Wollongong Local Planning Panel Assessment Report | 13 July 2021

WLPP No.	Item No. 3
DA No.	DA-2021/286
Proposal	Business premises - demolition of existing carpark, construction of a 117 place child care centre and parking for 82 cars
Property	44-46 Hopetoun Street Woonona Lot 1000 DP 1169057
Applicant	Zaki Property
Responsible Team	Development Assessment and Certification - City Wide Team (KR)

ASSESSMENT REPORT AND RECOMMENDATION

Figure 5: Excerpt from Chapter B4 Woonona Town Centre

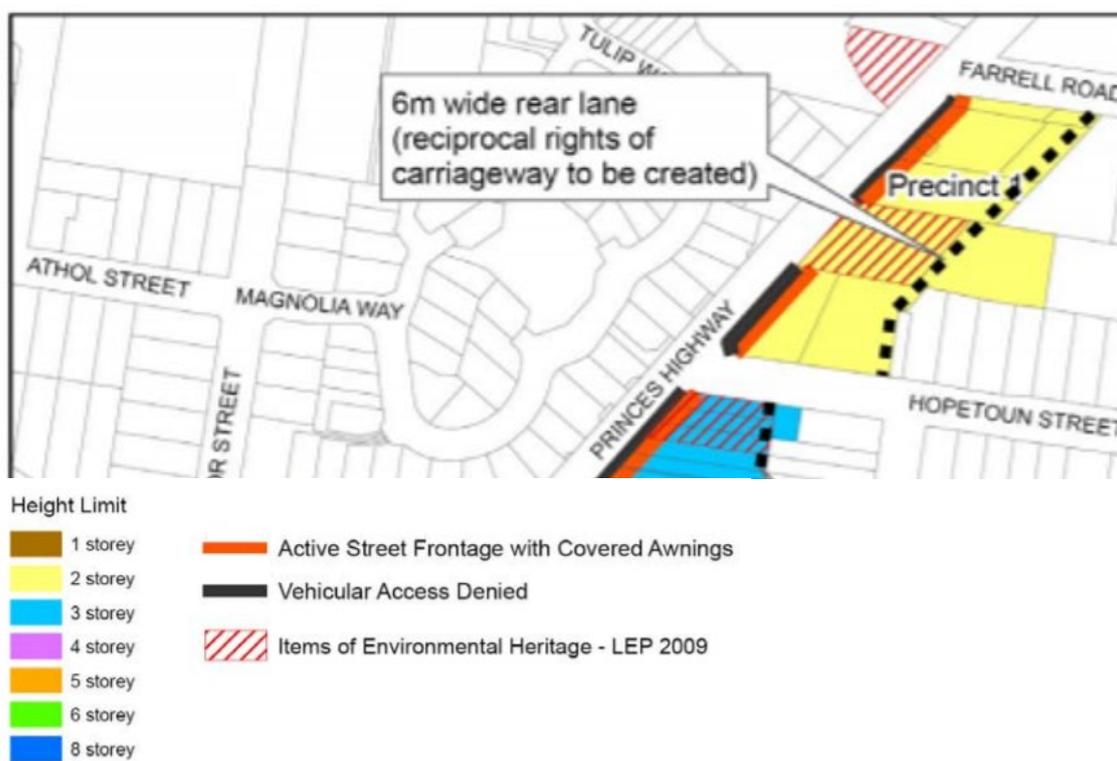
3. Maximum Building Height (Max. Number of Storeys) - 2 storeys as per Figure 5 below – Does not comply. No variation has been requested by the applicant. The exceedance in number of storeys is not supported as it would have a detrimental impact on character of the area, amenity of adjoining residents and significance of adjacent heritage items.

SHEET TITLE:
 GROUND FLOOR PLAN
 1 : 100 @ A1 sheet
 SCALE
 8696 DA-04
 JOB No. DRAWING No.
 ISSUE

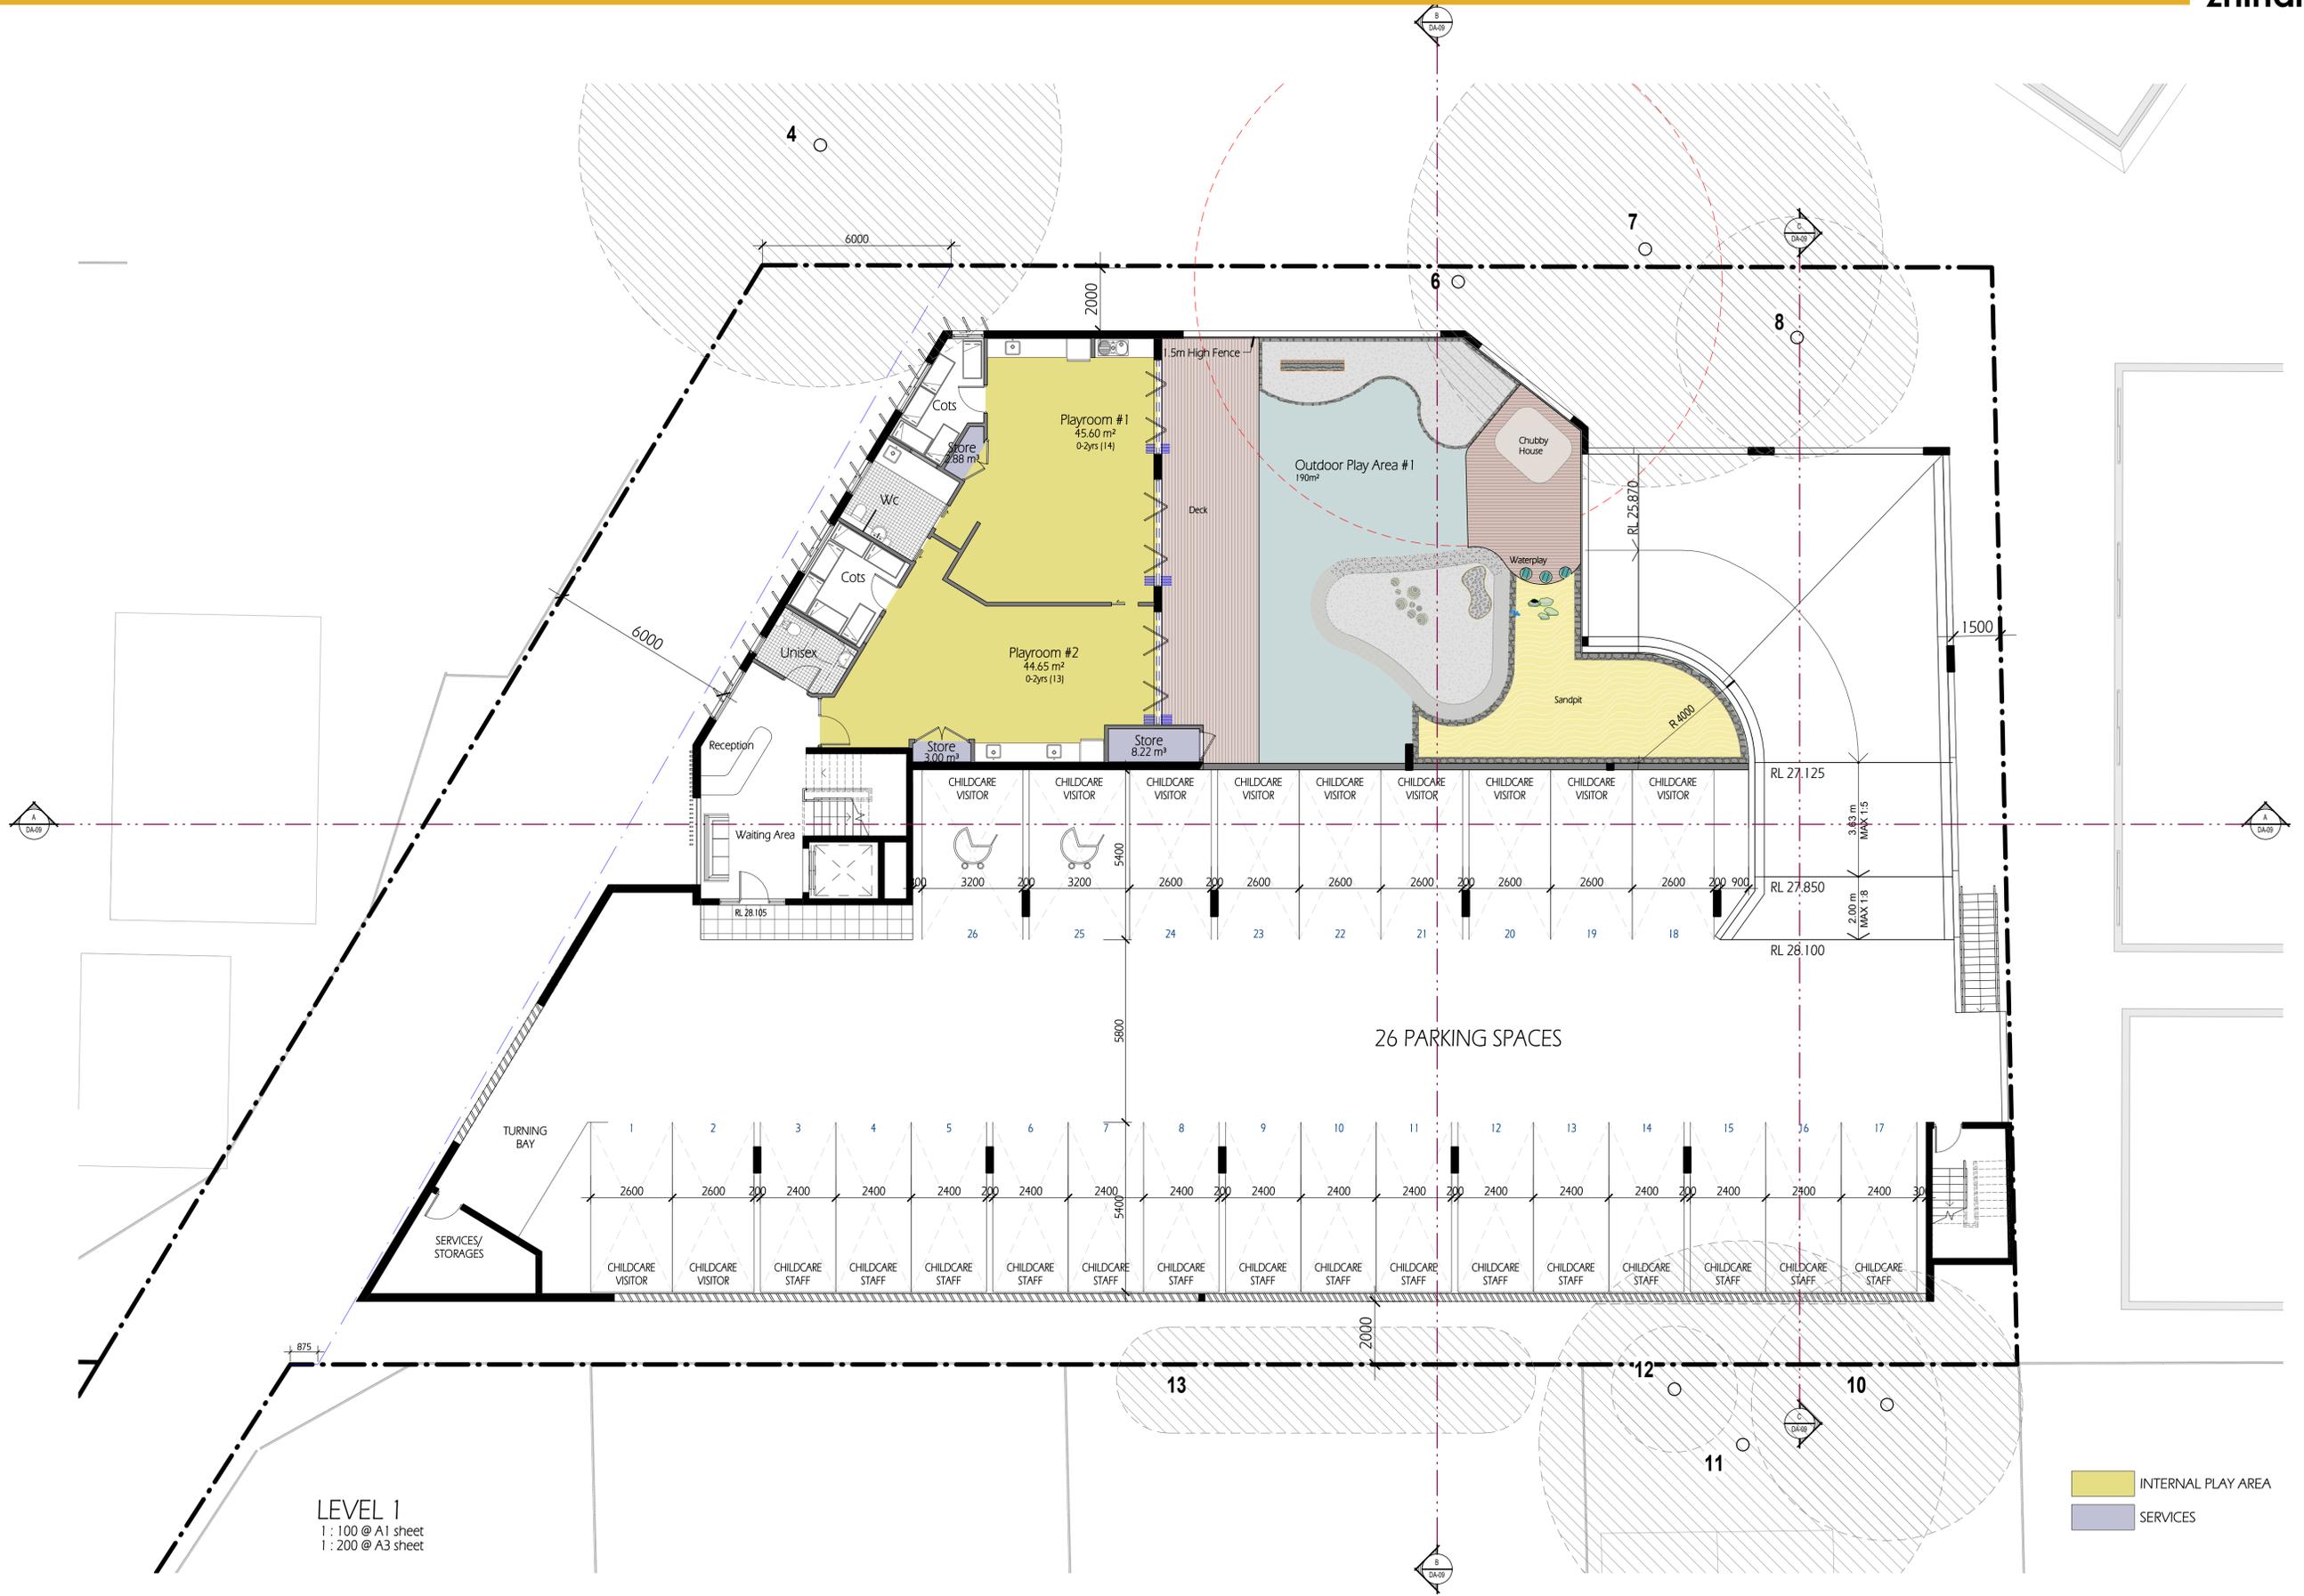
There is no clear demarcation for pedestrian movement on either the Ground Floor (DA-04) or Landscape (L-01) plans. This does not meet the requirements of The Child care Planning Guideline C7 which states that:
